Intersection ID: 44302	Main Street: KIEV_DR	Cross Street: PAULINE_LN	Location:	SE
ADA ID: 1C09A6D56948	Ramp Type: PerpDiag	Initial Pass/Fail: Fail	Overall Compliance: No	Severity Score: 8.75

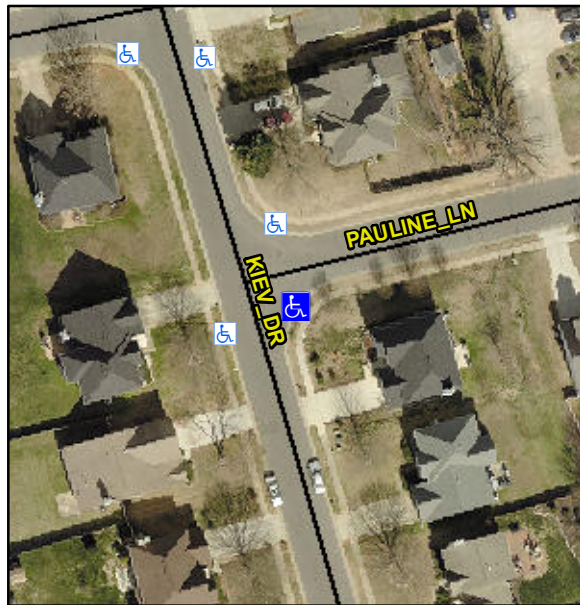
**Not Found, R304.5.1**

Compliance	Description	Data	Compliance	Description	Data
N/A	Ramp Length (in)	48.5	Yes	Ramp Slope (%)	7.0
No	Ramp Width (in)	46.0	Yes	Ramp XSlope (%)	0.9
N/A	Flare Type LT	N/A	N/A	Flare Type RT	N/A
N/A	Flare Slope LT (%)	N/A	N/A	Flare Slope RT (%)	N/A
N/A	Flare Traversable LT?	N/A	N/A	Flare Traversable RT?	N/A
N/A	Landing Length (in)	N/A	N/A	DWS Provided?	N/A
N/A	Landing Width (in)	N/A	N/A	DWS Contrast?	N/A
N/A	Landing Slope (%)	N/A	N/A	DWS Length (in)	N/A
N/A	Landing X Slope (%)	N/A	N/A	DWS Full Width?	N/A
N/A	Landing Curb? (Y/N)	N/A	N/A	DWS Offset (in)	N/A
N/A	Shared Landing?	N/A			
N/A	Gutter Ponding?	N/A	N/A	Gutter Slope (%)	N/A
N/A	Gutter Lip Ht (in)	N/A	N/A	Gutter X Slope (%)	N/A
N/A	Painted X Walk1?	No	N/A	Painted X Walk2?	No
	X Walk 1 Direction	To N		X Walk 2 Direction	To W
N/A	X Walk 1 Width (in)	N/A	N/A	X Walk 2 Width (in)	N/A
	X Walk 1 Slope (%)	0.9		X Walk 2 Slope (%)	3.5
	X Walk 1 X Slope (%)	2.8		X Walk 2 X Slope (%)	1.6

**Remove & Replace Curb Ramp With Two New Directional Ramps or Equivalent.**
